Re: REQUEST FOR ADDITIONAL INFORMATION UNIVERSITY OF FLORIDA TRAINING
REACTOR DOCKET NO. 50-83

**REQUEST FOR ADDITIONAL INFORMATION
UNIVERSITY OF FLORIDA TRAINING REACTOR
DOCKET NO. 50-83**

(November 26, 2008)

Figure 2 schematic of UFTR secondary coolant system used for determination of heat exchanger inlet/outlet pressures.

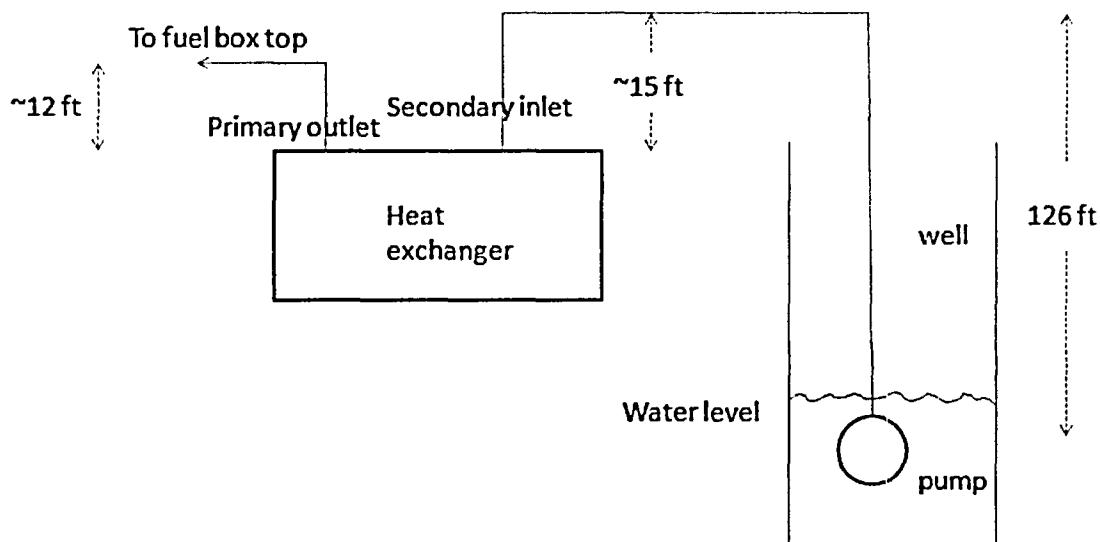
Is the assumption that a significant leak would be detected in the primary water resistivity valid if the reactor is operating at the TS limit of 36 gpm or 41 gpm primary flow rate (or normal primary flow rate if it is in excess of the allowed TS limit) and 60 gpm or 8 gpm secondary flow rate? In your response, address how the primary and secondary pressures are affected by the flow characteristics in the heat exchanger.

The heat exchanger shell-side and tube-side inlet/outlet pressures are not monitored in UFTR. However, we can estimate the pressures based on the piping layout and pump characteristics. Figure 5-5 in UFTR SAR shows the schematic of UFR secondary coolant system. The figure is also attached in this document (Appendix A). A simplified version of Figure 5-5 in SAR is used here to estimate the primary outlet and secondary inlet pressures as shown in Figure 2

The well pump, model *150H10* is manufactured by Goulds Pumps, ITT Industry. The specifications of the pump are given in Appendix B. According to the data given in the Appendix, the pump at 10 hp, for 200 gpm, has a dynamic head of 163 ft. In Figure 3,

the height difference between the pump and heat exchanger is ~111 ft (126 ft minus 15 ft). Assuming no significant pressure loss in the pipes, the secondary inlet pressure is about 50 ft (163 ft minus 111 ft) water above the atmosphere pressure. While on the primary side, the height from the heat exchanger to the top of fuel box (where the pressure is atmosphere) is ~12 ft. The primary outlet pressure is about 12 ft water above the atmosphere pressure. Considering 1 psi is equal to 2.306 ft water, then the inlet pressure for the secondary is ~36.4 psi, and the outlet pressure for the primary is ~19.9 psi. Considering the expected pressure drop in the heat exchanger give in Table 2, the secondary outlet pressure is ~34.2 psi, which is ~72% higher than the primary outlet pressure. This difference increases as the secondary flow rate decreases, e.g., at 100 gpm with a dynamic head of 238 ft, the pressure difference is ~251%. This means that there is always a negative pressure which prevents any leak from the primary loop to the secondary loop.

Figure 1 - Comparison of the activity release for different operation time as a function of sodium concentration (100 kW, 1 liter/hr, 60 gpm)

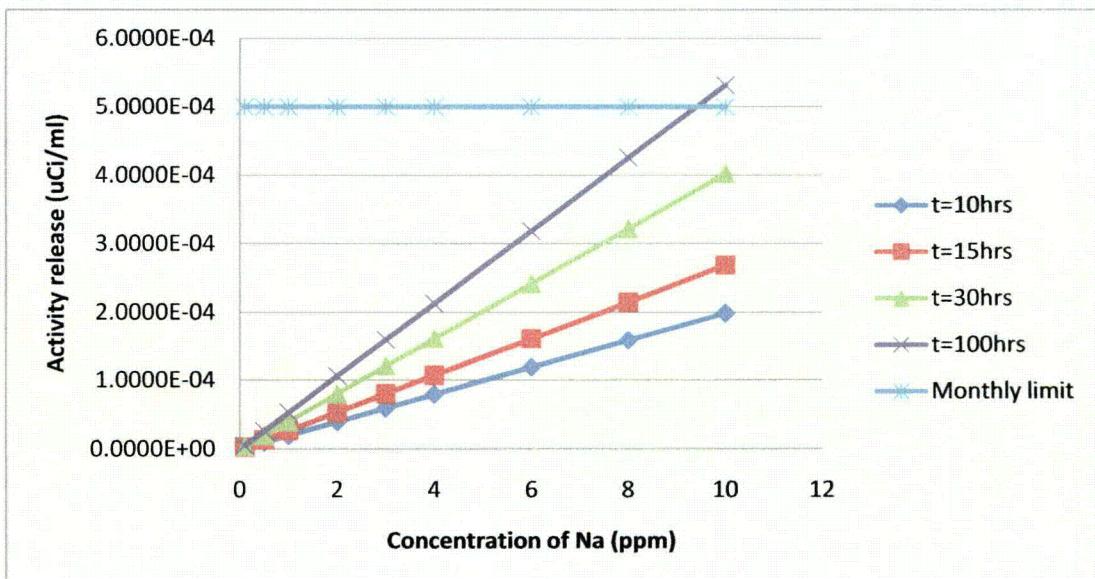
Question 2a: What is the basis for the ‘assumptions of 1 ppm sodium in the primary coolant, activation for 10 hours, and 1 liter/hour leak rate for 1 hour?’

Here, in order to examine the effect of higher Na concentration and longer operation times, we evaluate the activity release for concentrations in a range of 1-10 ppm for operation hours of 10 to 100 hrs. Figure 1 compares the activity release for different hours of operation as a function of Na concentration in the primary coolant. Note that these calculations are based on 1 liter/hr leakage rate, and 60 gpm secondary flow rate.

Above figure indicates that the activity is less than the monthly limit if sodium concentration is less than 9 ppm even at an unrealistic case of 100 hrs of operation. Only, for cases with concentrations between 9 ppm and 10 ppm the concentration exceeds the limit for the 100 hrs operation case. Further, this diagram indicates at a more realistic value of Na concentration of 1 ppm and operation time of 10 hrs, the activity release is less than the limit by a factor of ~25.

Figure 3 - Comparison of the activity release for different sodium concentrations as a function of secondary flow rate for 1 liter/hr leakage (operation time of 10 hrs, 100 kW).

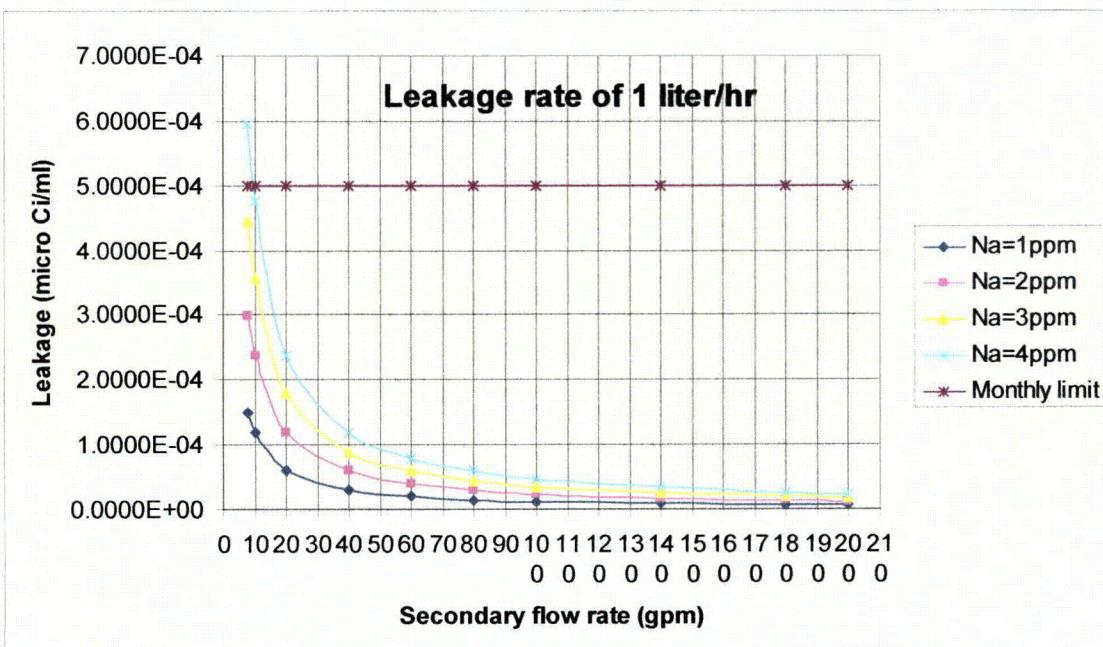
Question 2c. As discussed previously, the TS limit on secondary flow rate is 60 gpm when using well water and 8 gpm using city water. Therefore, provide an estimated effluent concentration assuming the allowed TS limits for secondary flow.

UFTR has two secondary water supplies: i) well water; ii) city water. UFTR operates on the well water, and city water is used as a temporary backup for normal shutdown. Based on the current UFTR Technical Specifications, the nominal well water flow rate is ~ 200 gpm. A warning is triggered if flow drops to 140 gpm or less, and the reactor is tripped if the flow rate drops to 60 gpm or less. The nominal city water flow rate is ~ 30 gpm, and reactor is shutdown if the flow rate drops to 8 gpm or less. In order to examine the effect of secondary flow rate for both well and city waters, in Figure 3, we compare the leakage rate for different Na concentrations as a function of different flow rates for operation time of 10 hrs and leakage rate (primary to secondary) of 1 liter/hr at 100 kW.

Above figure indicates even if the secondary flow is as low as 8 gpm, the leakage activity is less than the limit for Na concentrations of up to 3 ppm. If the secondary flow rate is between 100 gpm to 200 gpm, where the latter is the nominal value, for a more realistic Na concentration of 1 ppm, the leakage activity varies in the range of 1.2×10^{-5} to 6×10^{-5} which is significantly smaller than the limit by a factor of ~40 to ~100.
